Certificate of Appropriateness

Property1921 N. 2ND ST.Description of workInstall 22' of 6' high clear cedar solid dog ear design fencing with one 4' x 6' gate. Install 91' of
6' high solid dog-ear red cedar fencing with two gates.

Date issued 5/9/2019 PTS ID 114752 COA: fence

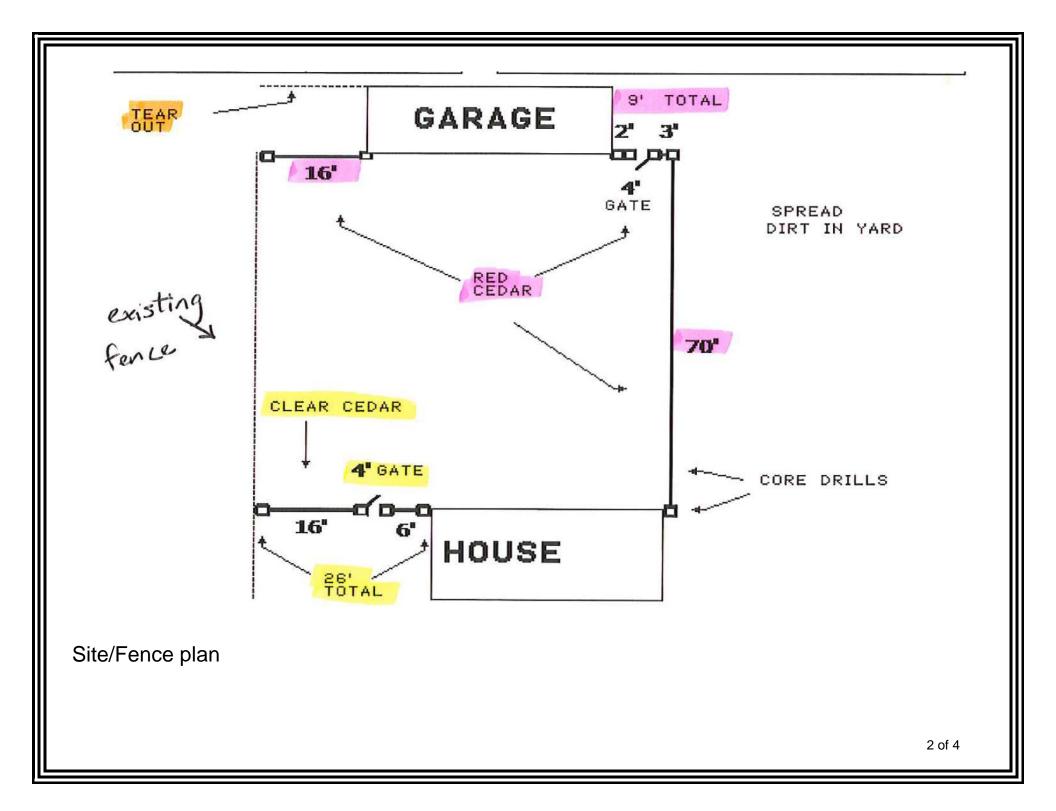
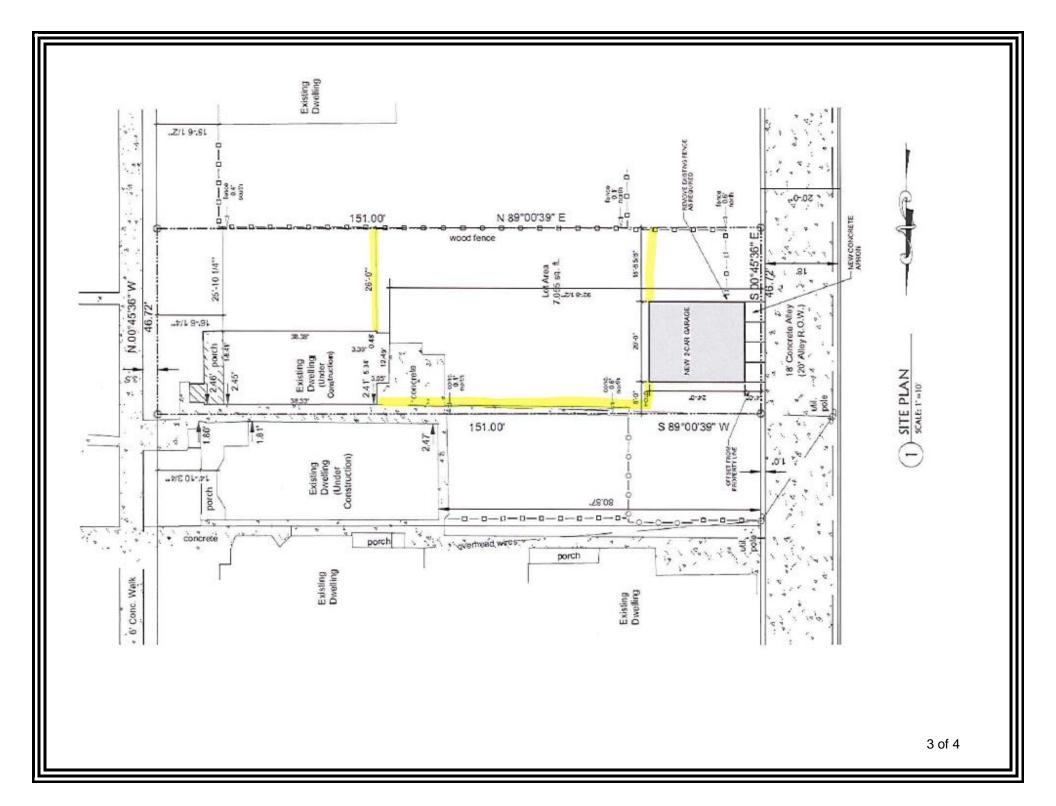
All wood must be smooth and equivalent to #1 grade cedar or better for use in rear and side yards. Sections of fence forward of or in line with the primary building's front setback must be clear grain. Wood fences must be painted or stained with an opaque stain upon completion. Note: when new, bare wood is left exposed to the exterior elements for a period of only a week or two, the life the of the paint job subsequently applied to it will be decreased.

General design. Note that clear-grain wood is required for the 26' section in line with the house.
